MIL-PRF-19500/337L
AMENDMENT 1
5 February 2014
SUPERSEDING
MIL-PRF-19500/337L
15 March 2013

PERFORMANCE SPECIFICATION SHEET

SEMICONDUCTOR DEVICE, DIODE, SILICON, SWITCHING, TYPES 1N4153-1, 1N4153UR-1, 1N4153UB, 1N4153UBCA, 1N4153UBCC, 1N4153UBD, 1N4153UBN, 1N4153UBND, 1N4534, AND 1N4534UB, JAN, JANTX, JANTXV, JANHC, AND JANKC

* FIGURE 3. Physical dimensions, surface mount (UB and UBN version).

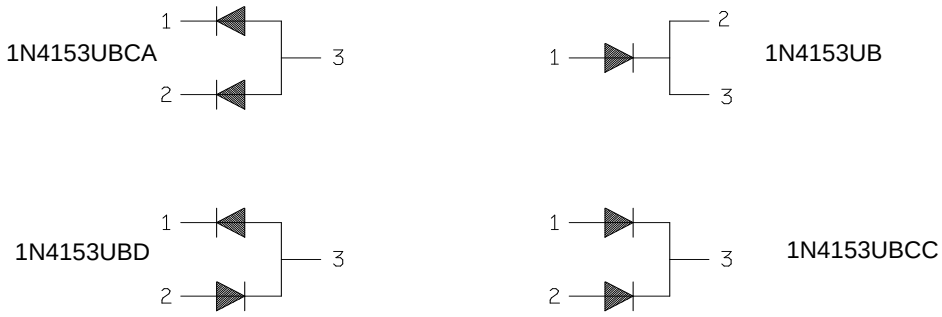
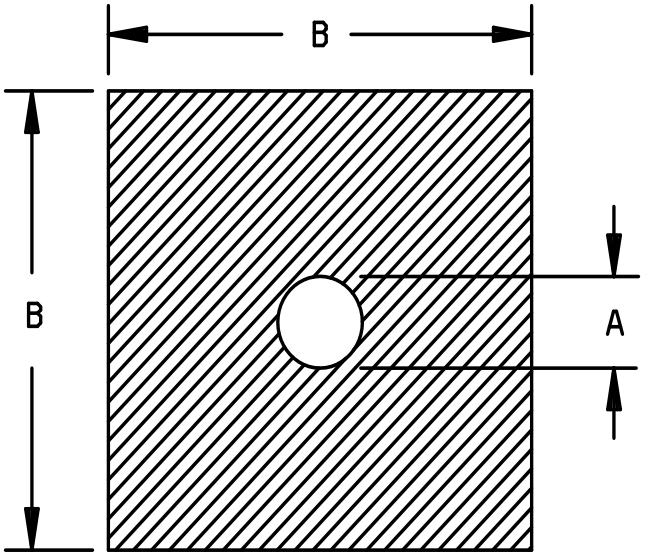
NOTES:
1. Dimensions are in inches.
2. Millimeters are given for general information only.
3. Hatched areas on package denote metallized areas.
* 4. For design reference only.
* 5. In accordance with ASME Y14.5M, diameters are equivalent to ϕx symbology.
